APPLICATION NO.	FILING DATE	FIRST NAMED INVENTOR	ATTORNEY DOCKET NO.	CONFIRMATION NO.
10/803,337	03/18/2004	Xiaoyu Li	DP-310459	5568
22851	7590	05/23/2006	EXAMINER	
DELPHI TECHNOLOGIES, INC.			BOES, TERENCE	
M/C 480-410-202			ART UNIT	
PO BOX 5052			PAPER NUMBER	
TROY, MI 48007			3682

Office Action Summary	Application No. 10/803,337	Applicant(s) LI ET AL.	
	Examiner Terence Boes	Art Unit 3682

DETAILED ACTION

Figure 1 – Figure 4 of US 2005/0199087

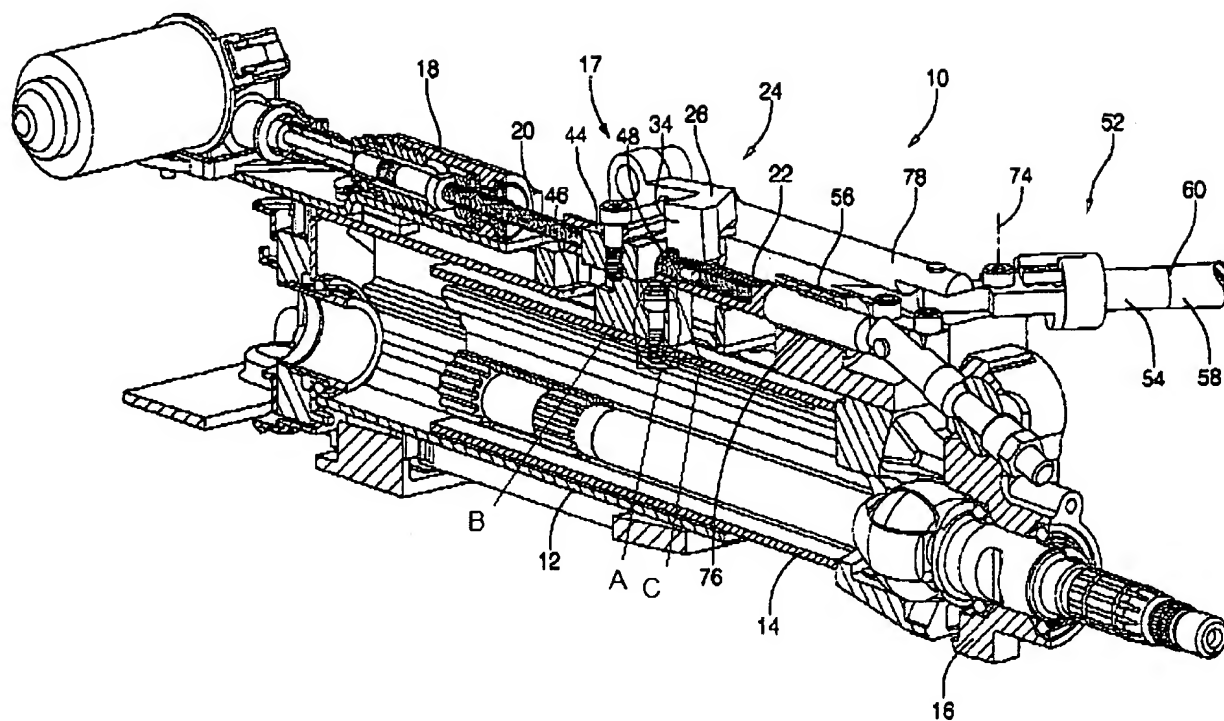
- First end (right side of (20) shown connected to (22)) pivotally connected to tilt housing (see fig 4, (20) is connected to tilt housing via (22))
- Second end (see fig. 4, left side of 20 is shown connected to lower steering column jacket via (18)) slidably connected to lower steering column jacket.

- Wherein said linking member moves linearly in response to telescoping and tilting movement (see fig 4).
- Wedge member (see fig 1 below, (A)) rotatably associated with lower steering column jacket and moveable between a locked position and unlocked position (wedge member can be tightened and locked or

- Single locking device includes a wedge member (A) disposed between said upper steering column jacket and linking member

- Lower steering column jacket defines an aperture (46) with an enlarged portion (enlarged portion is considered to be opening inside lower steering column jacket) wherein said wedge member (A) extends through said enlarged portion.

- Lower steering column jacket including a guide (18) having an aperture (see fig 4, right side of 18 shows an aperture which (20) passes through) for receiving second end.

- Single locking device includes first engaging element (see fig 1 below, (B)) fixedly associated with said upper steering column jacket and adjacent to said wedging element.

- Single locking device includes second engaging element (34) movably associated with lower steering column jacket and adjacent to linking member (see fig 4).

- Wherein said lower steering column jacket includes a first aperture (see fig 4, right side of 18 shows an aperture which (20) passes through) and a second aperture (see fig 4, left side of 18 shows an aperture which (20) passes through)

- Aperture (see fig 4, left side of 18 shows an aperture which (20) passes through) including an enlarged portion (see fig 4, enlarged portion is defined by threaded portion of aperture) and single locking device

including an engaging element (see fig 4, threaded bushing shown inside of (18) is considered to be an engaging element) in enlarged portion

- Said wedge member defines a pair of first surfaces (see figure below, (C) are top and bottom surfaces of wedge member) extending substantially parallel to one another and spaced from one another a first distance wherein said first distance is greater than a second distance defined between said linking member and said upper steering column jacket (see fig 4, length of wedge member appears greater than distance from linking member to upper steering column jacket)
